**GULF STATES UTILITIES COMPANY**

February 6, 1985  
RBG- 20,086  
File No. G9.5, G9.23,  
G9.8.6.2

River Bend Station - Unit 1  
Docket No. 50-458

Enclosed are revisions to the River Bend Station Final Safety Analysis Report for your information. Attachment 2 supplements and/or revises my letter of November 29, 1984 (RBG-19,576) on this subject. These revisions support previous discussions with your staff and will be appropriately included in a future FSAR amendment.

FSAR Figures 7.3-15  
Sheets 1 & 2

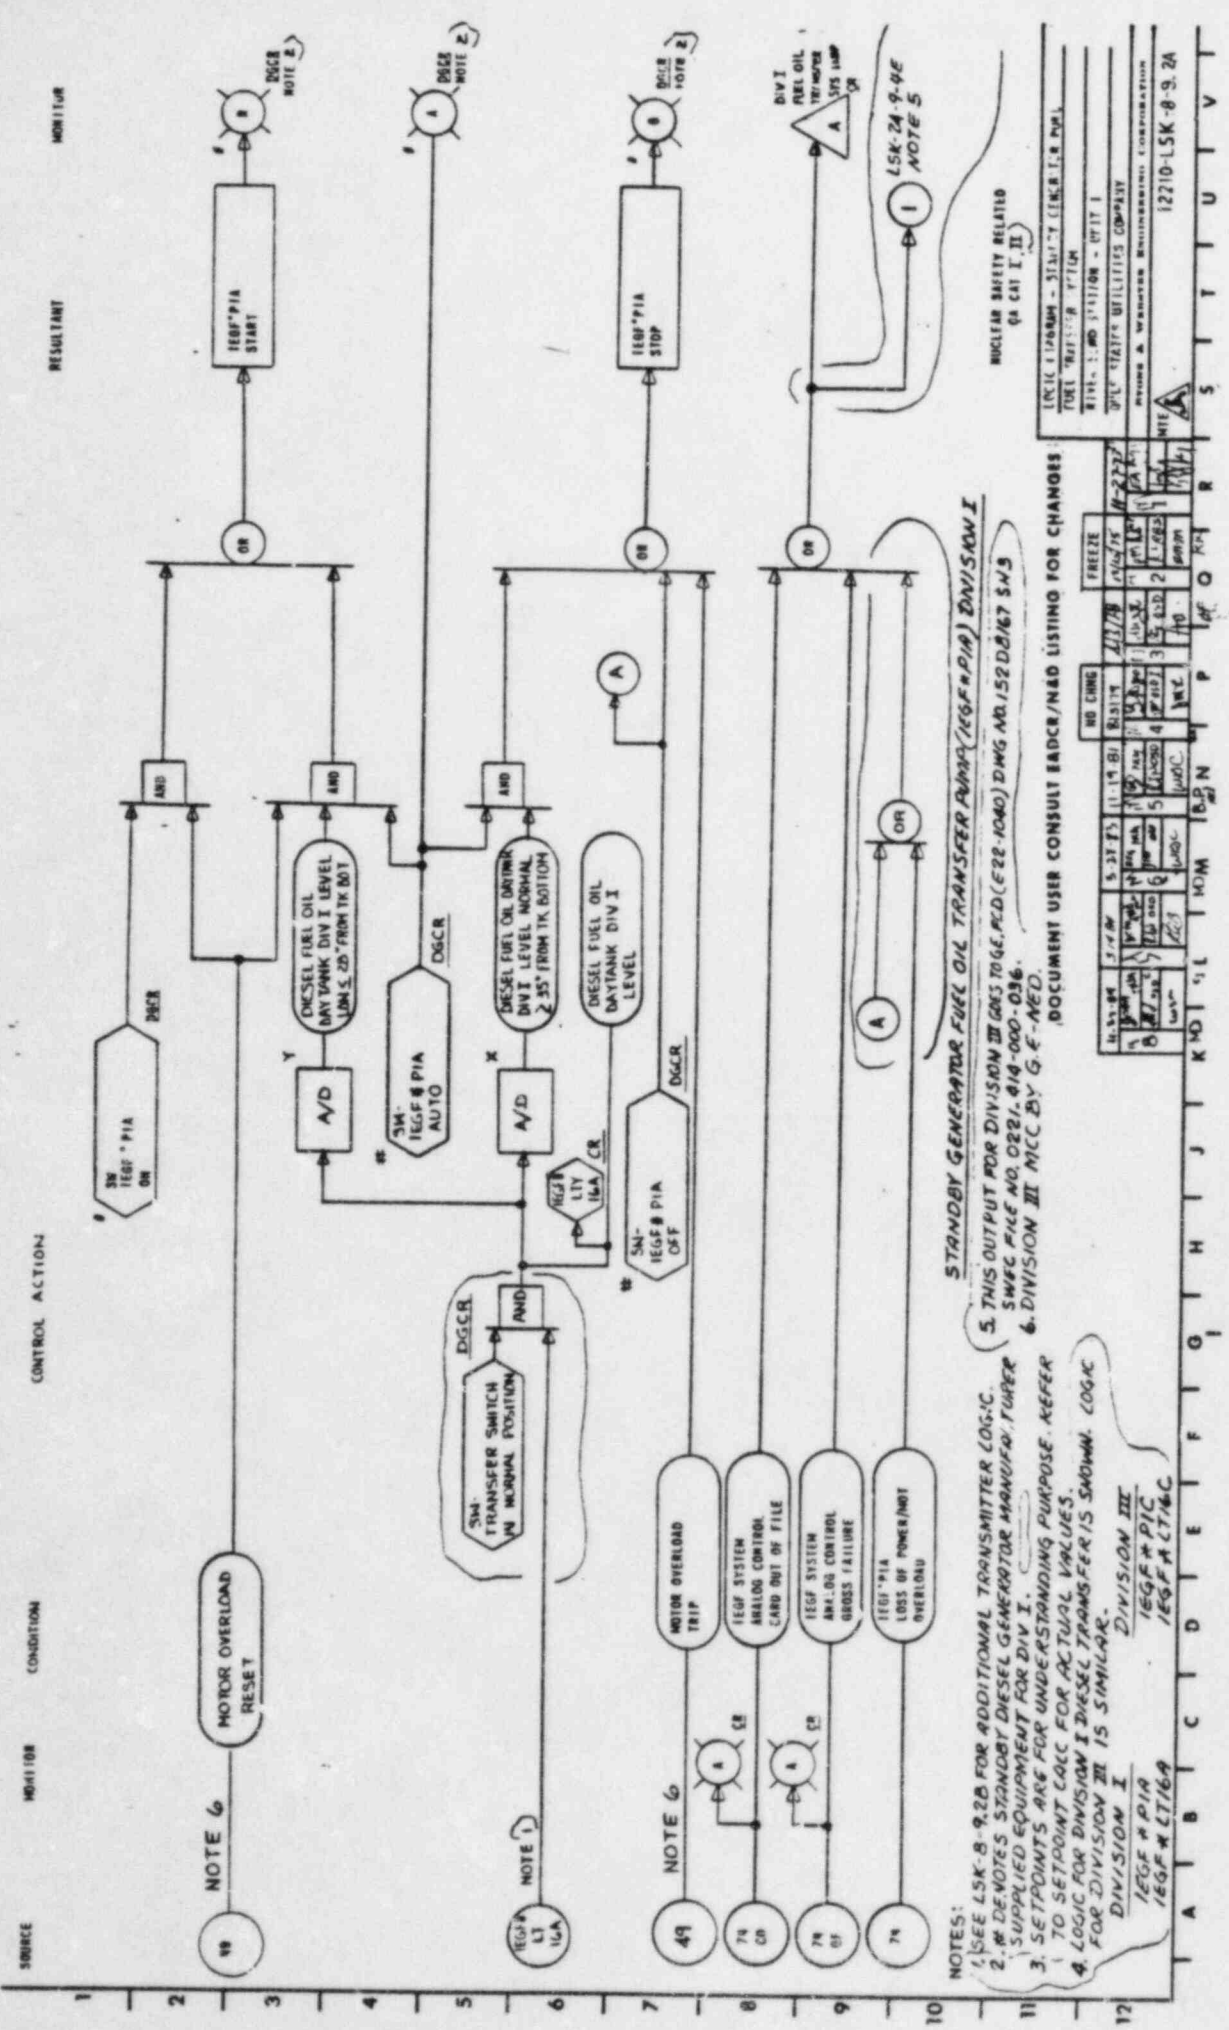
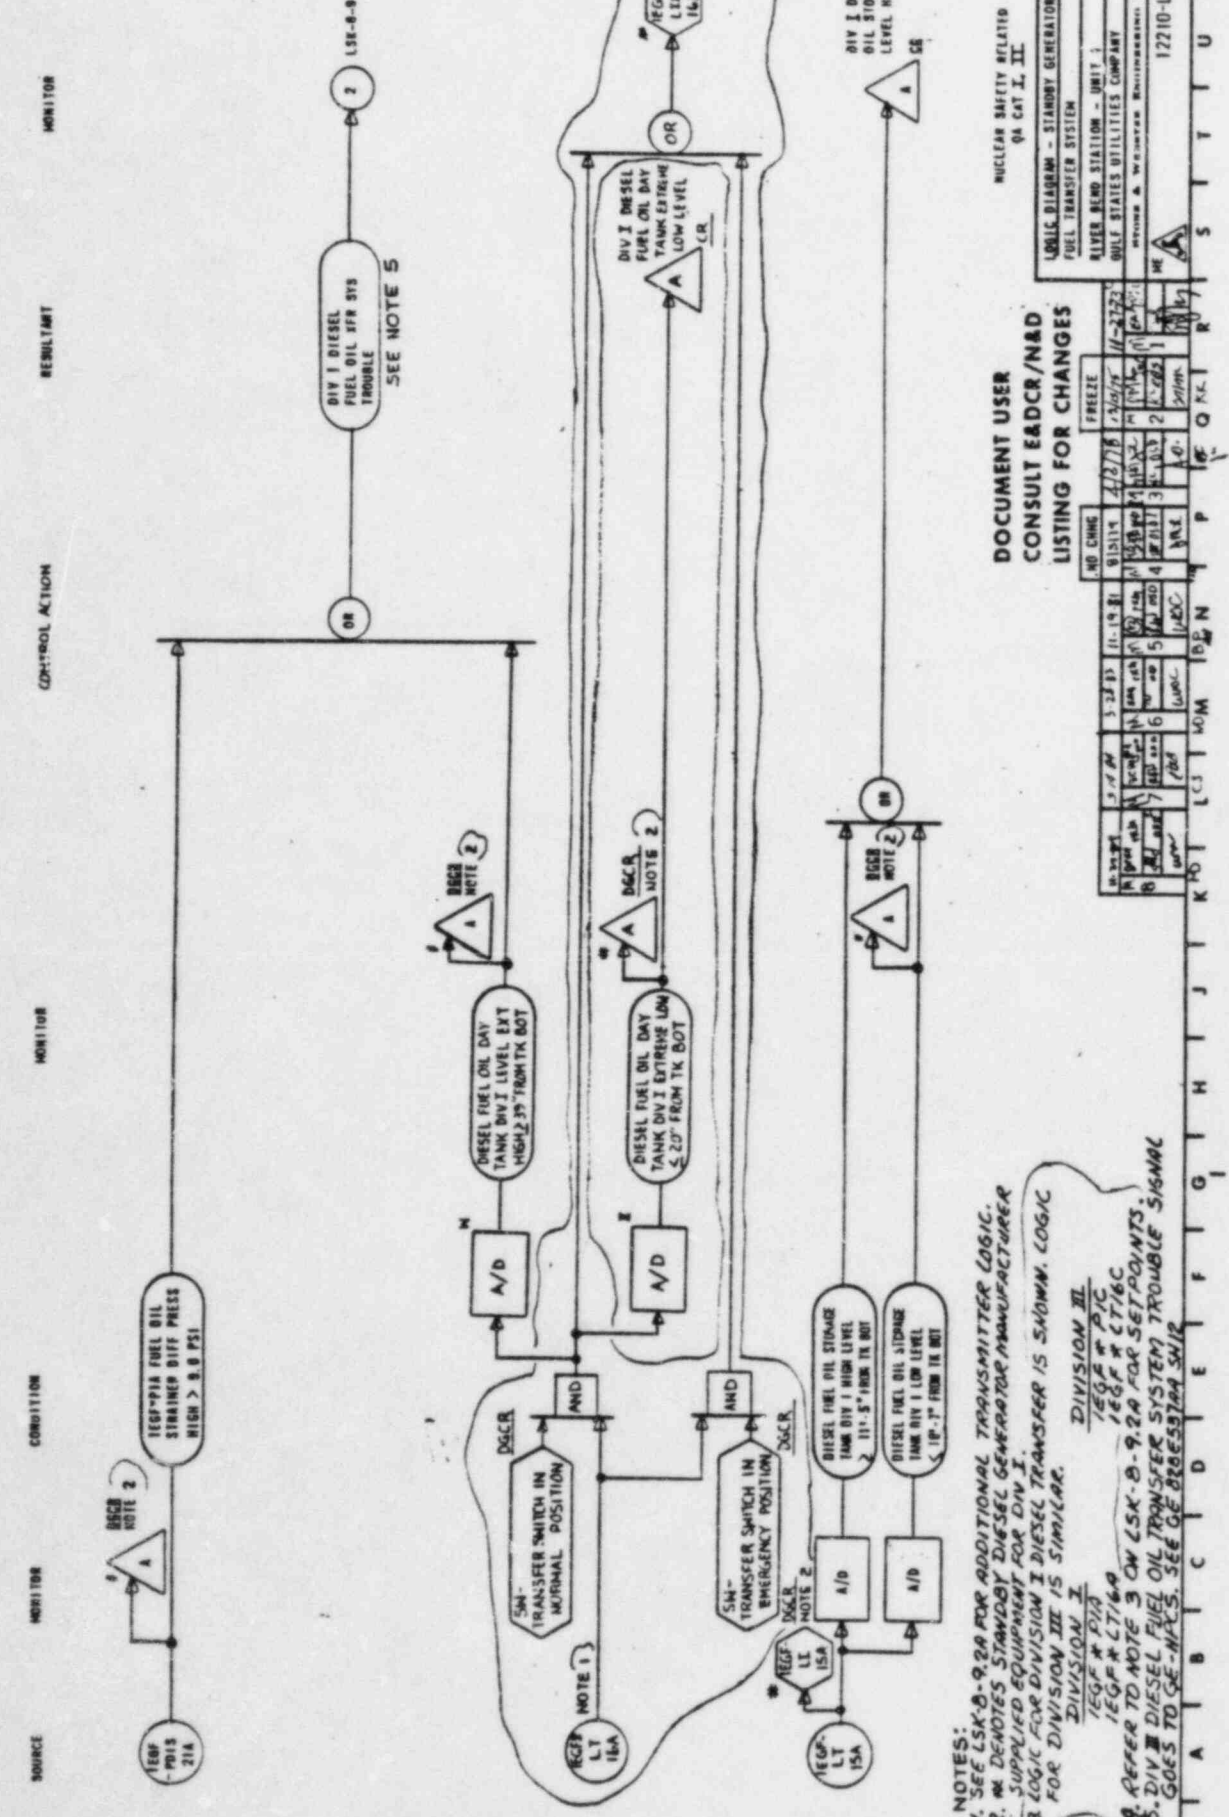
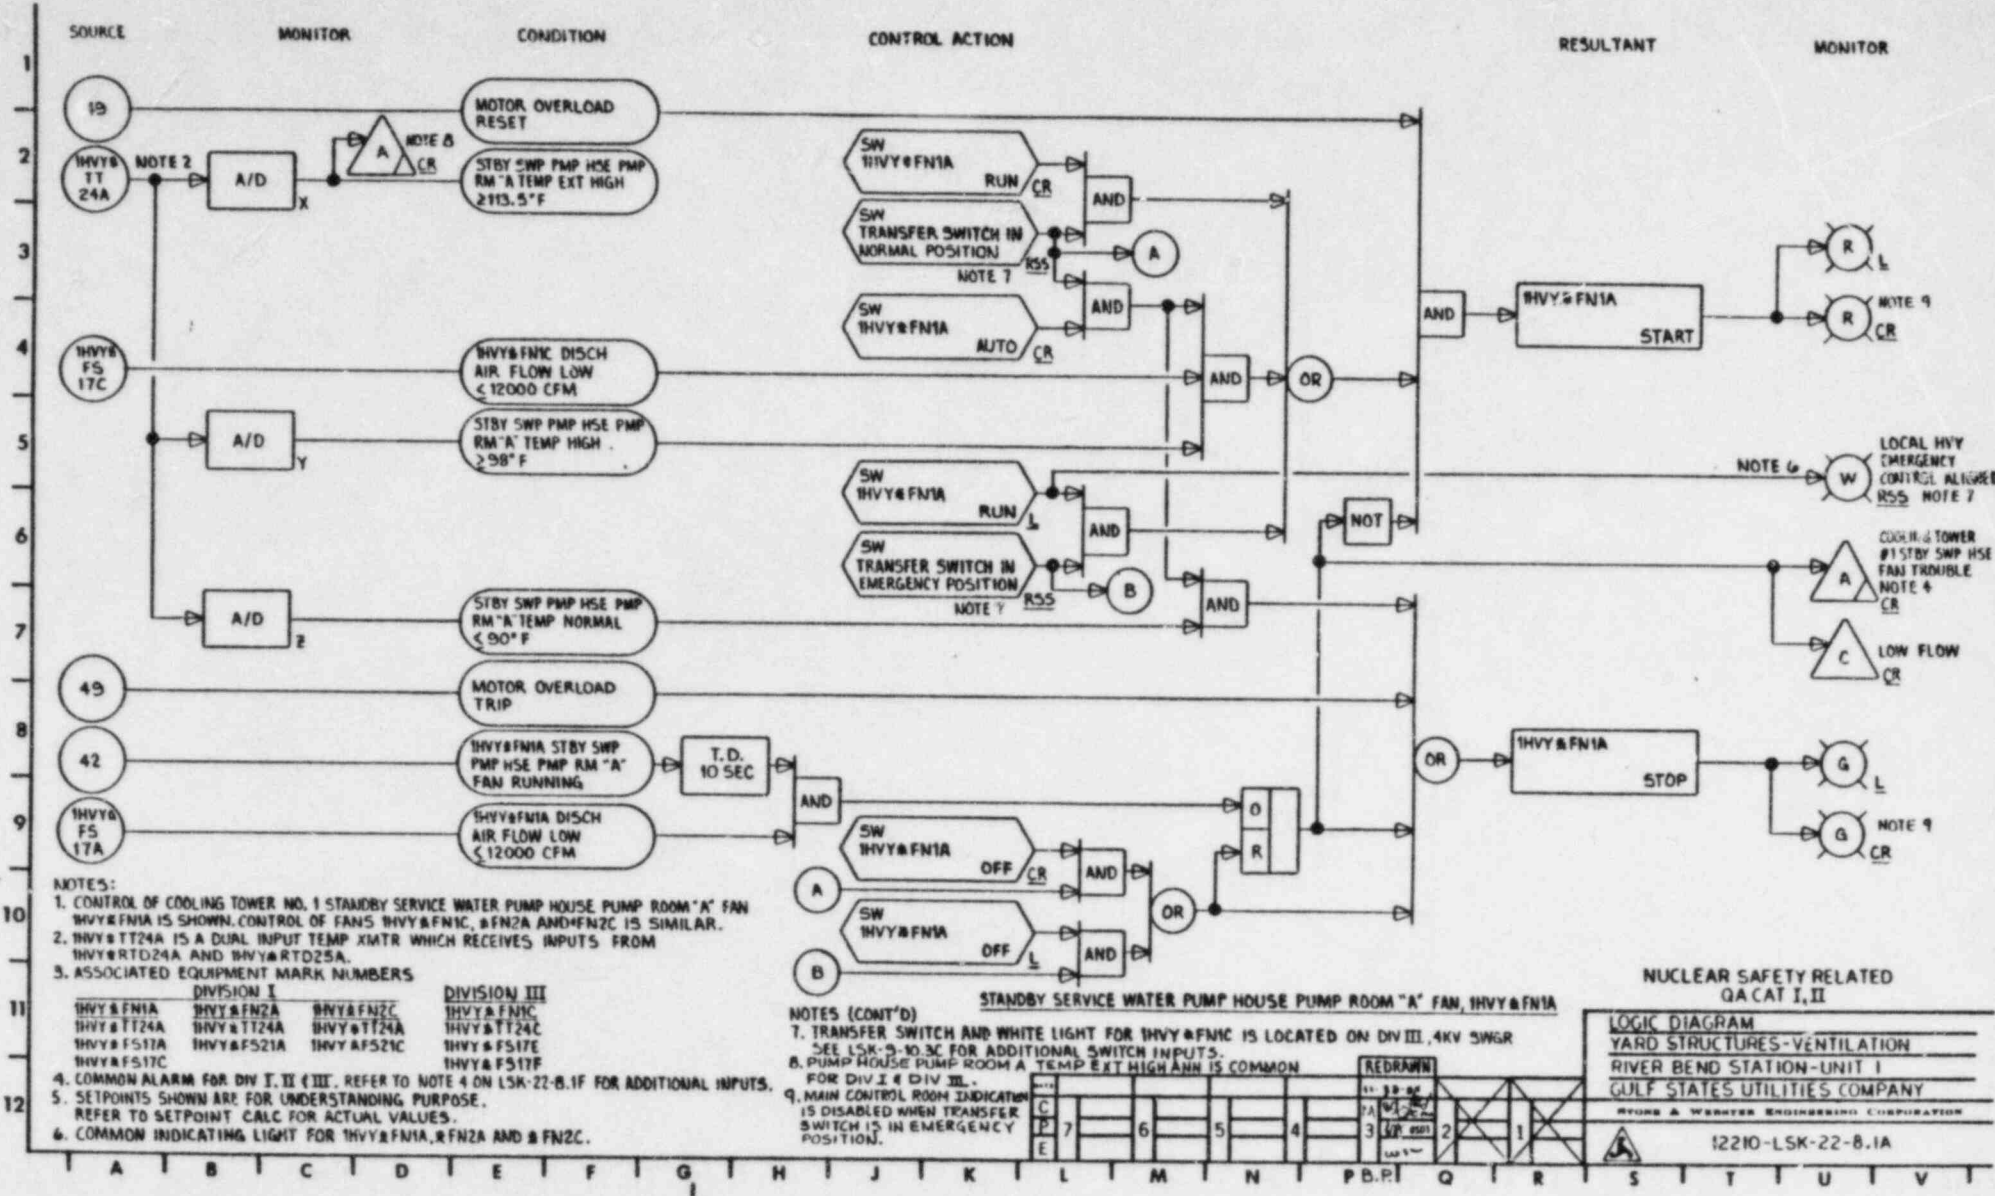
will be updated to reflect the attached LSK's.

FSAR Figure 7.3-20  
Sheet 4

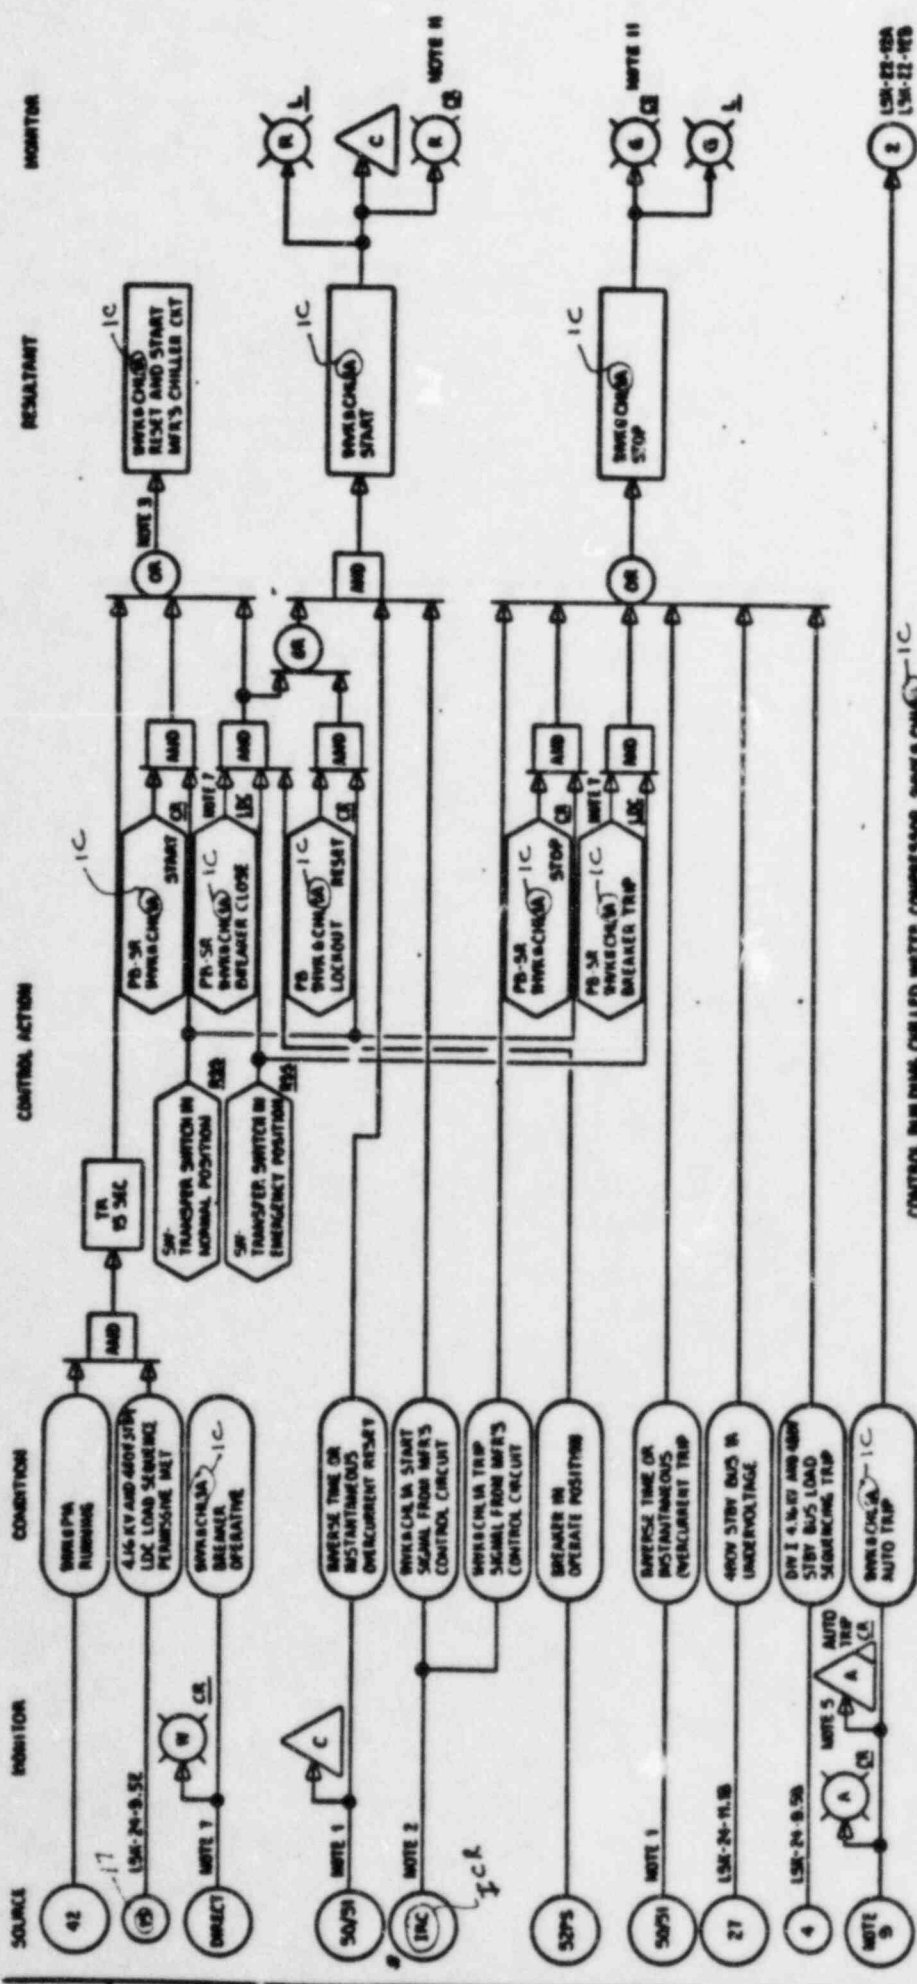
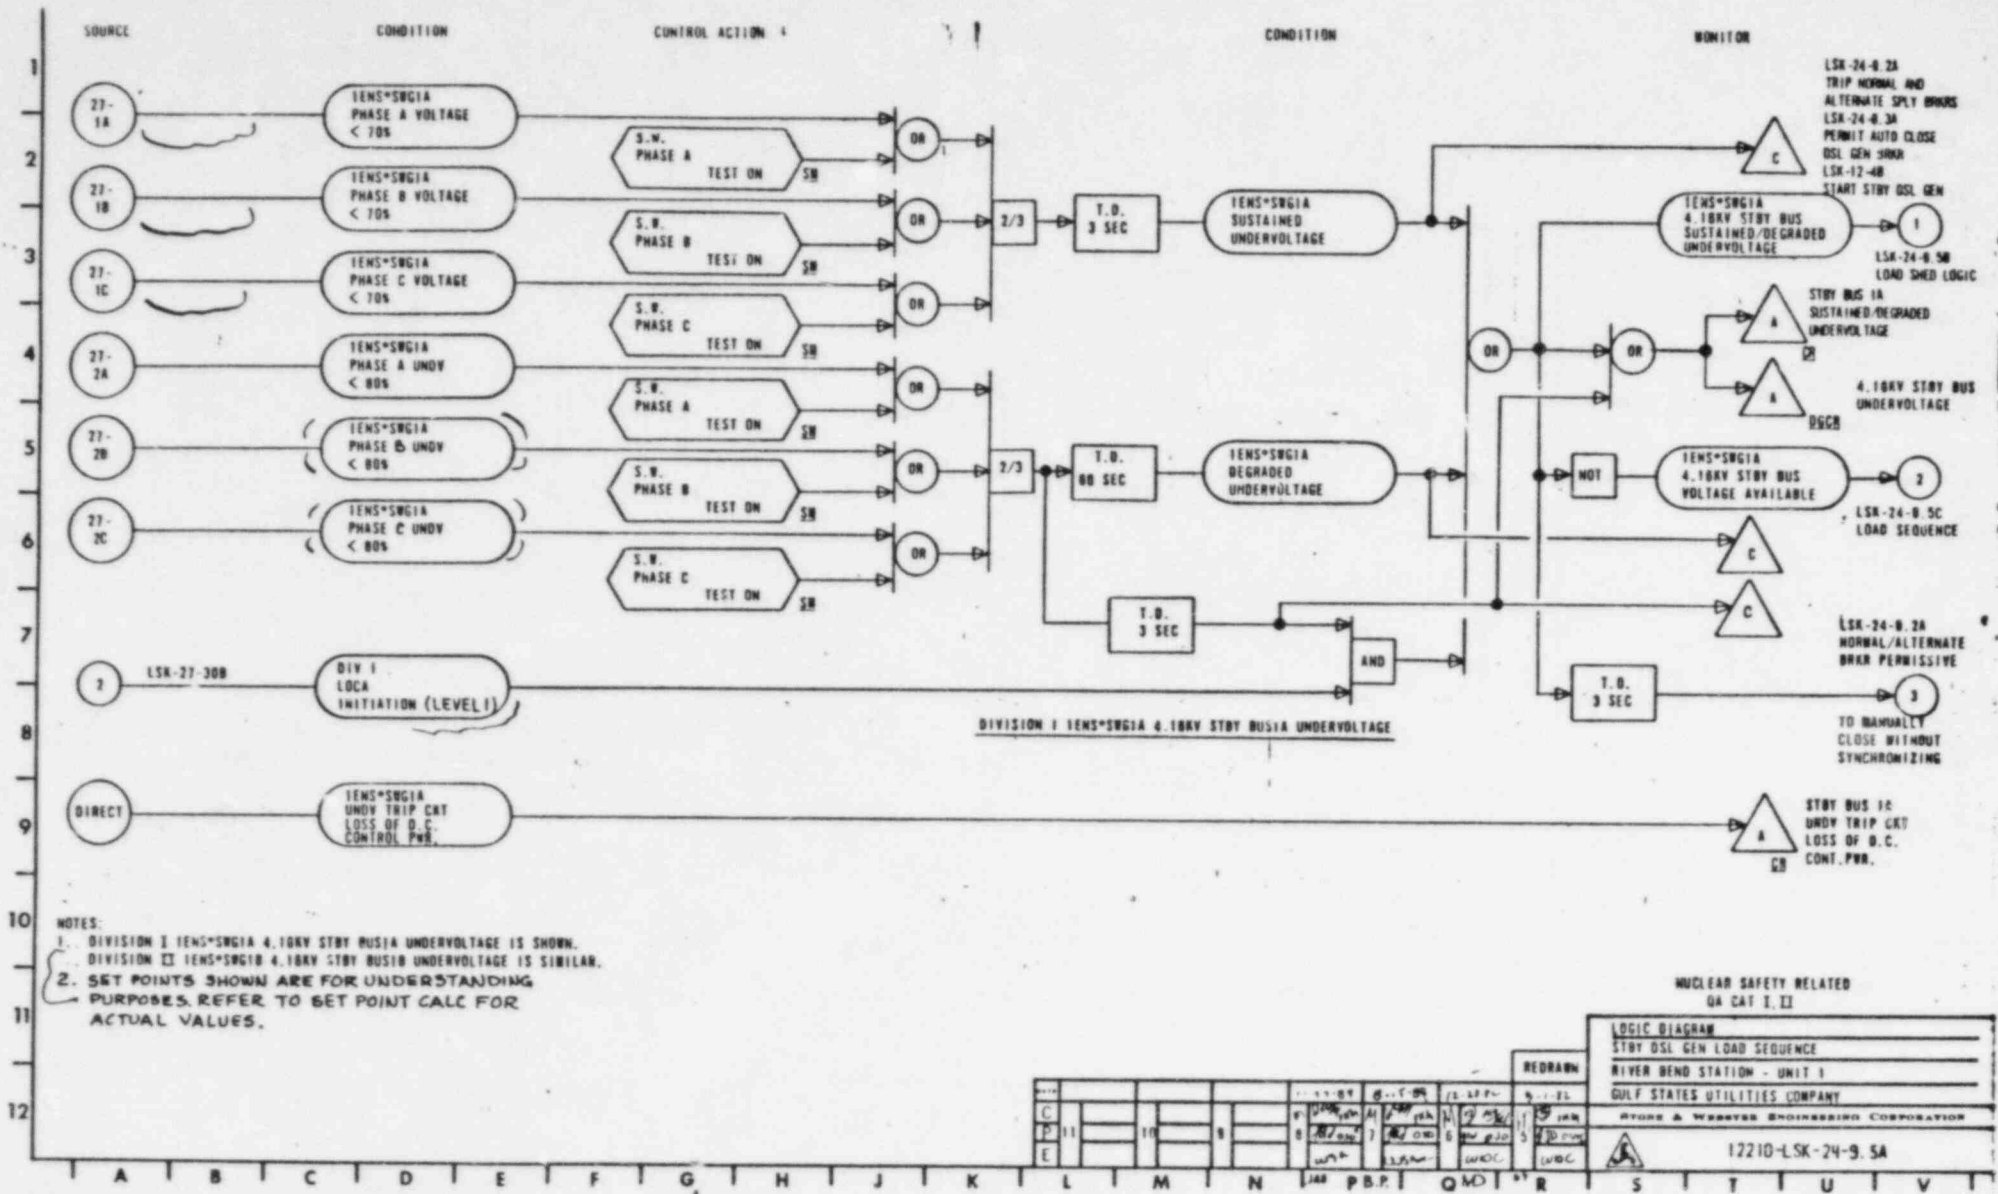
will be updated to reflect the attached LSK's.
